Plan Commission

Agenda

Monday, November 25, 2019

SUBJECT: Staff recommendation and possible action regarding a Site Plan request for a new office building and parking lot at 2100 BLK Innovation Court (Parcels WD-D0035-1-1, WD-D0036).

SHEET NO.
C3.0

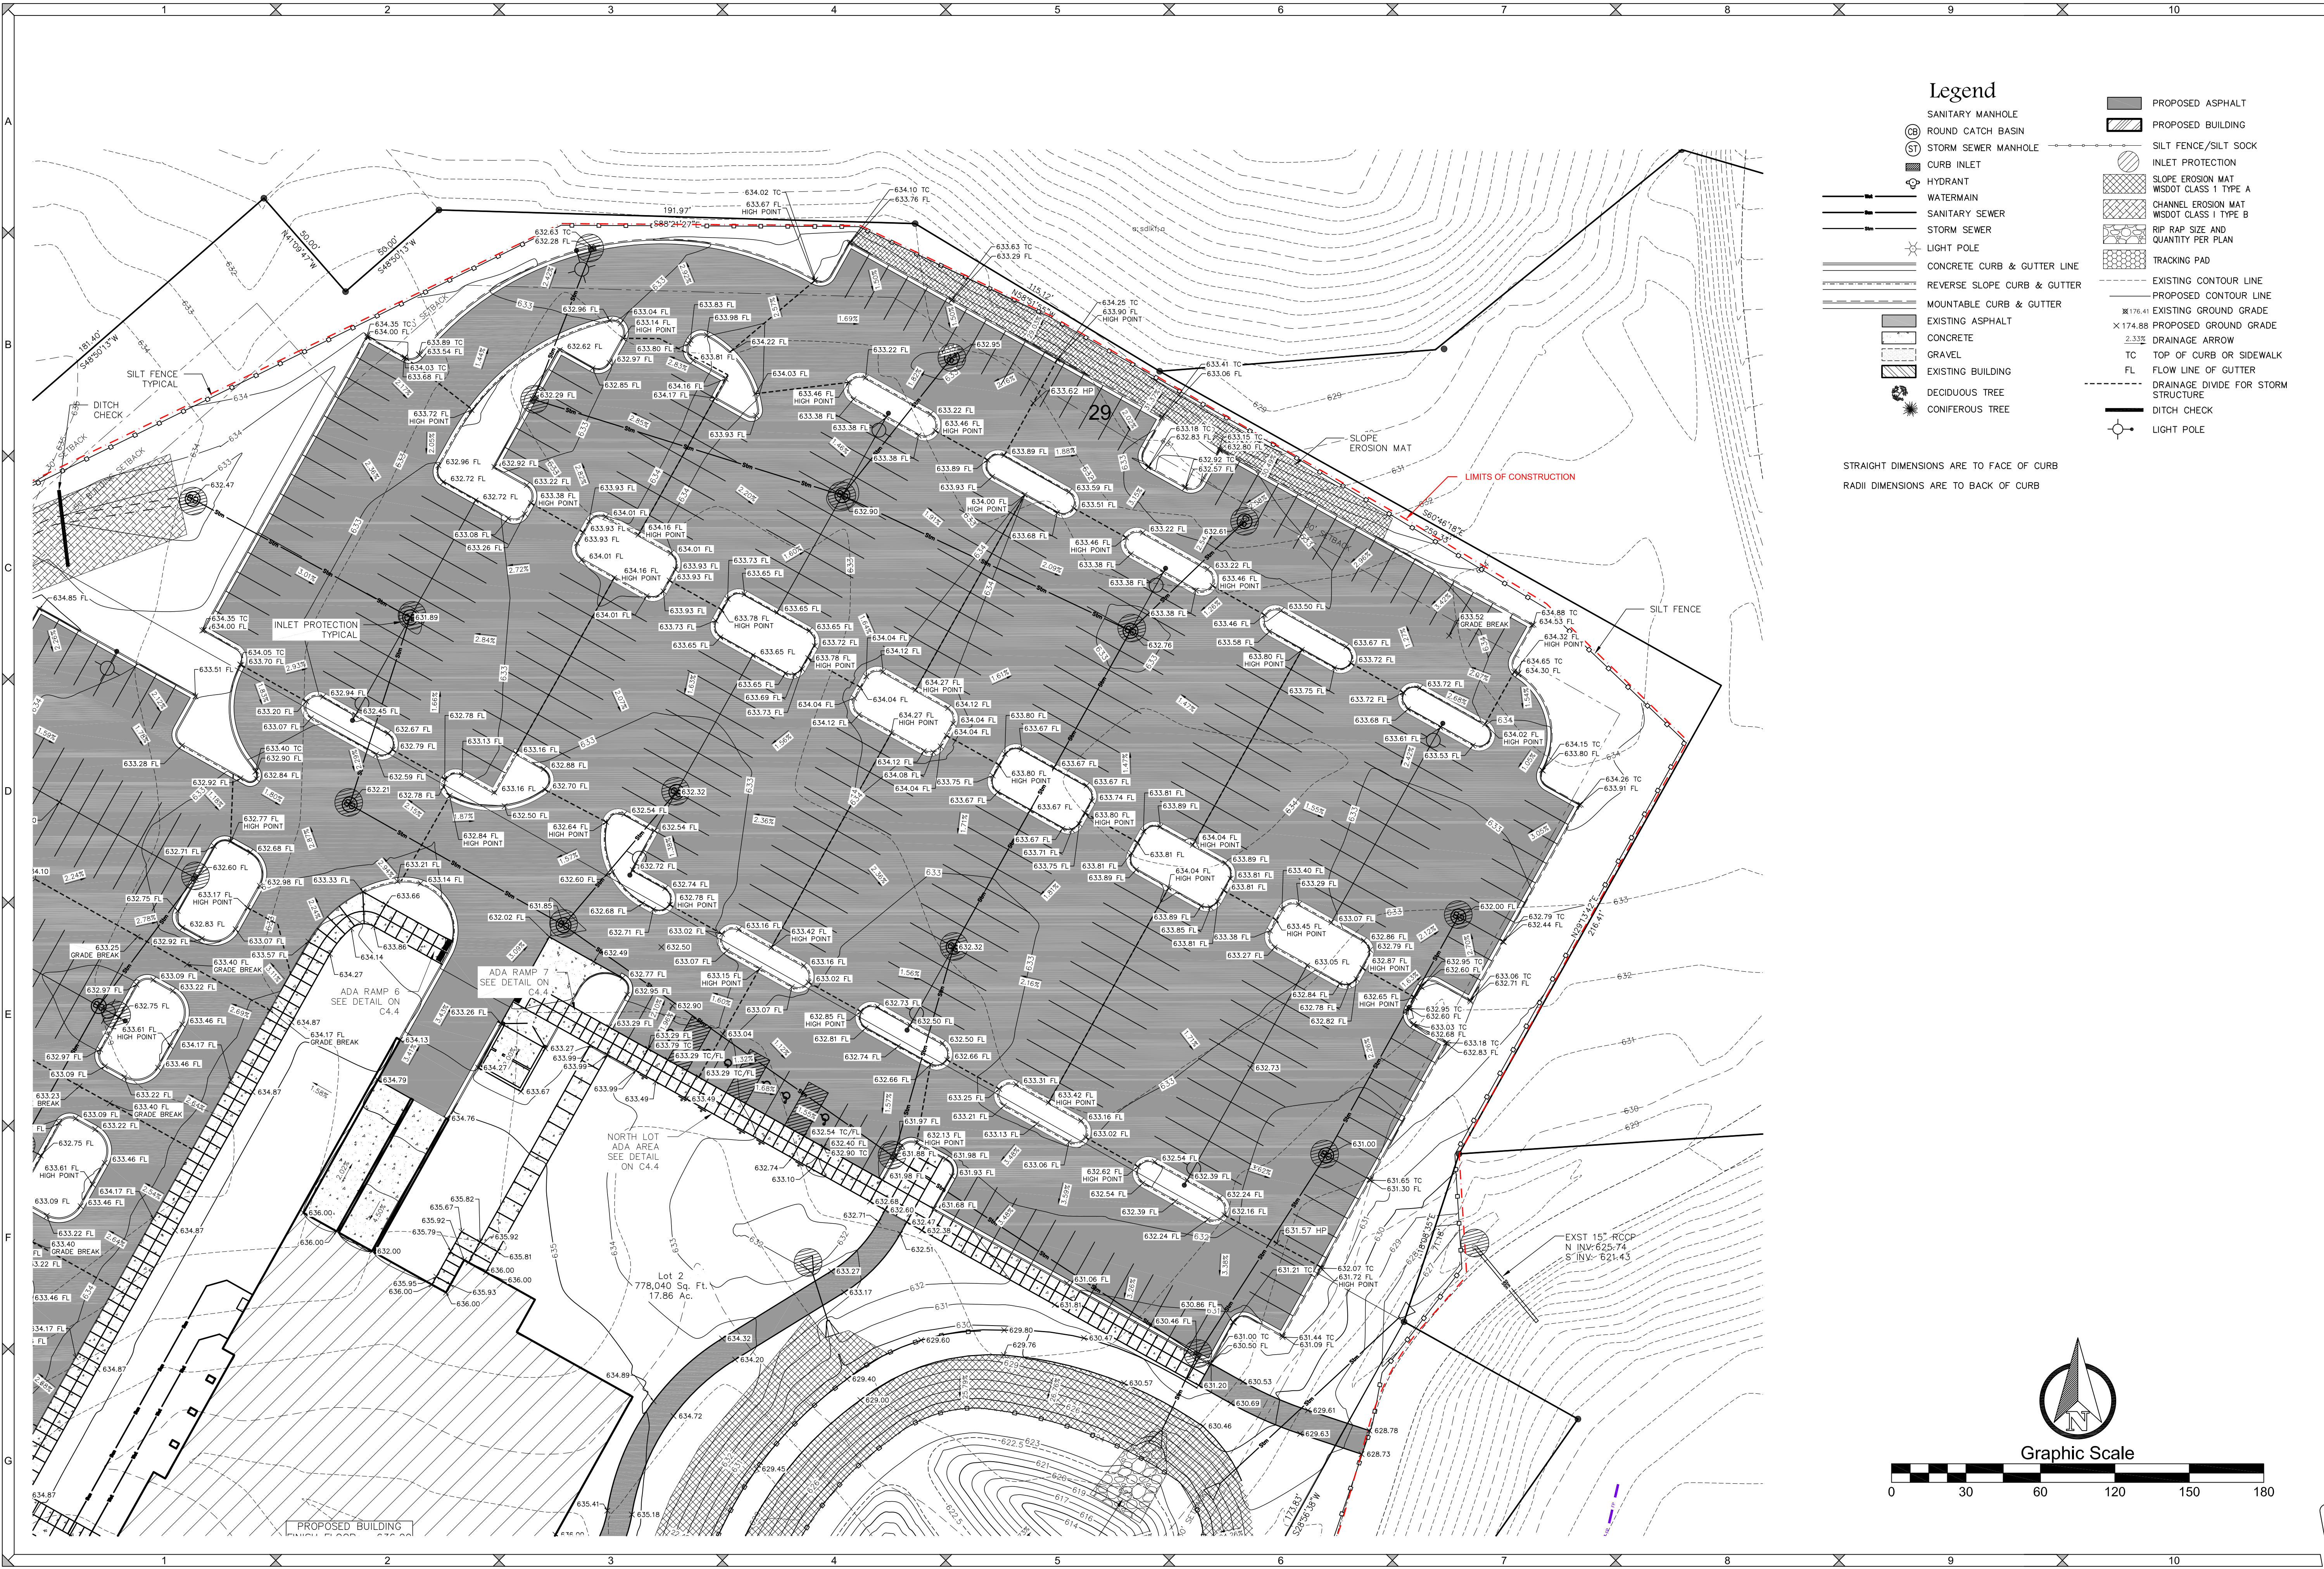
12. Sheet C3.0: Correct the existing contours, which are shown with the same line as proposed contours and not as the line in the legend.
13. Sheet C4.0: Remove existing contours and parking lot striping as they make it too difficult to see the storm drainage basins. (on all grading plans.)

SHEET NO.
C4.1

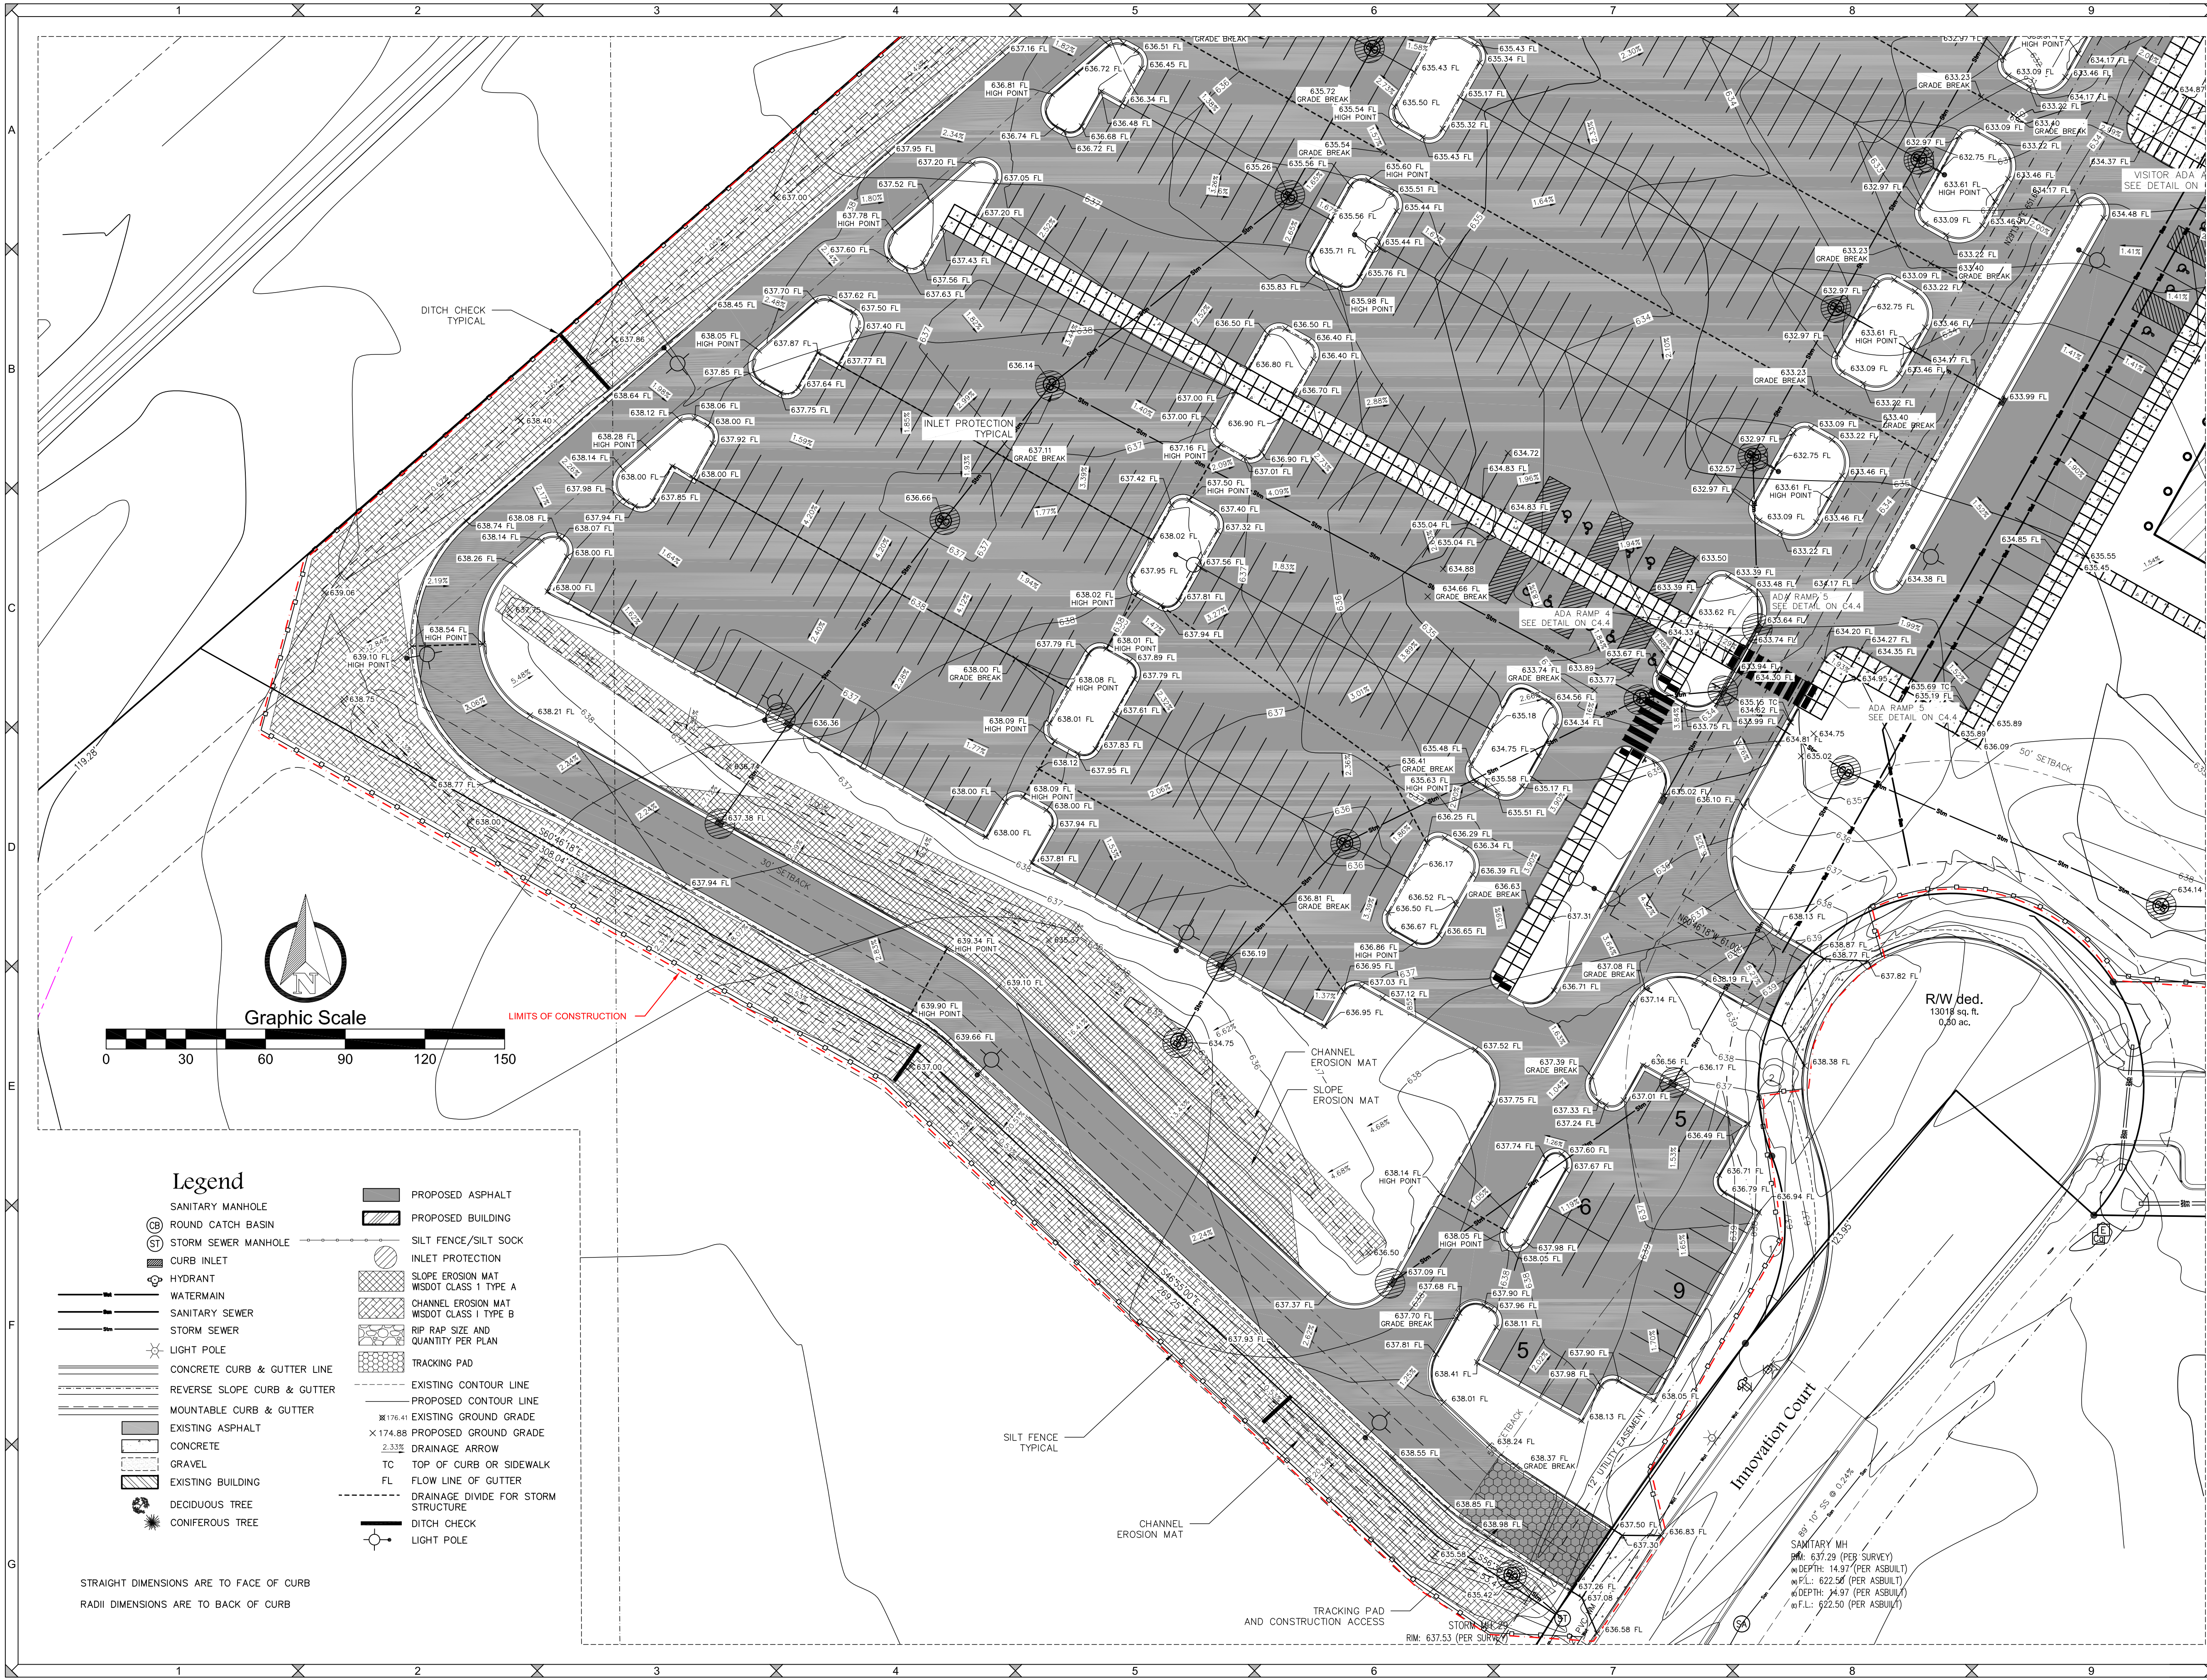
14. Sheet C4.1: Inlet protection is at incorrect location at catch basin W18.
15. Sheet C4.1: Rim/Flowline elevations are not provided for catch basins W18, W17, W16, W15, W14, W13 or W12.

SHEET NO.
C4.2

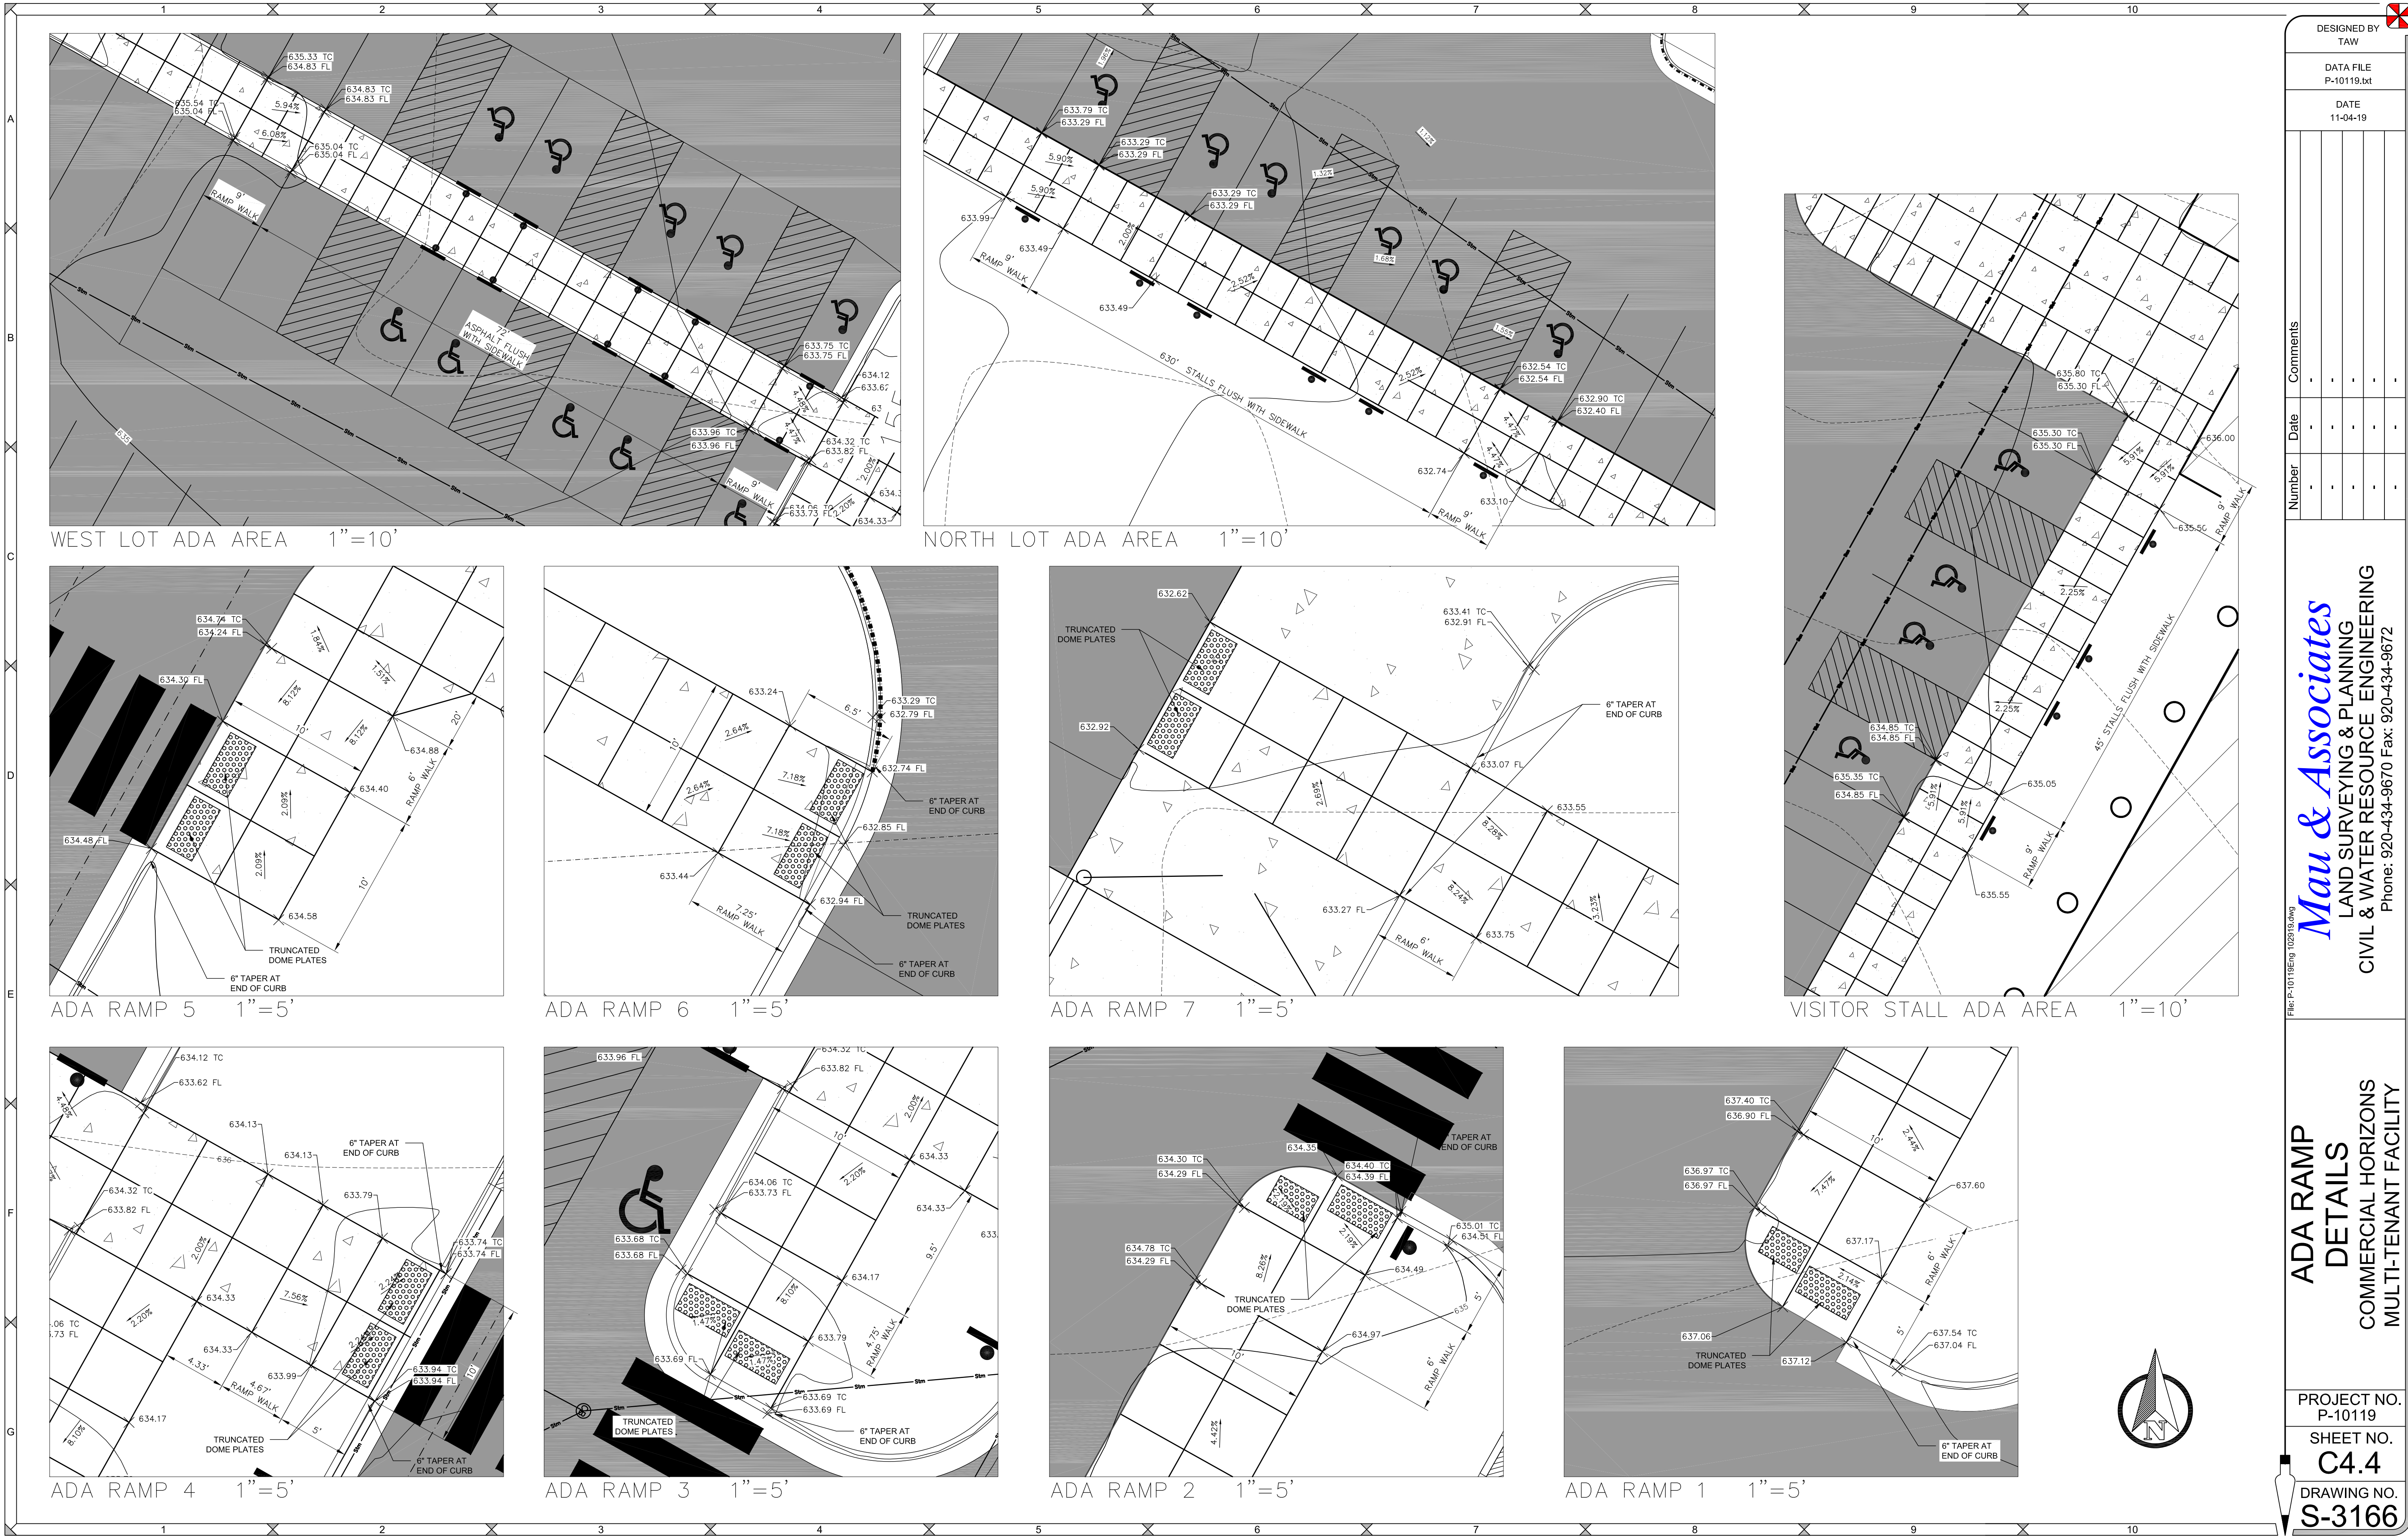
16. Sheet C4.2: Need rim elevation at catch basin W2.
17. Sheet C4.3: The City's parking lot at Outlot 2 is being revised which will impact the trail's location.
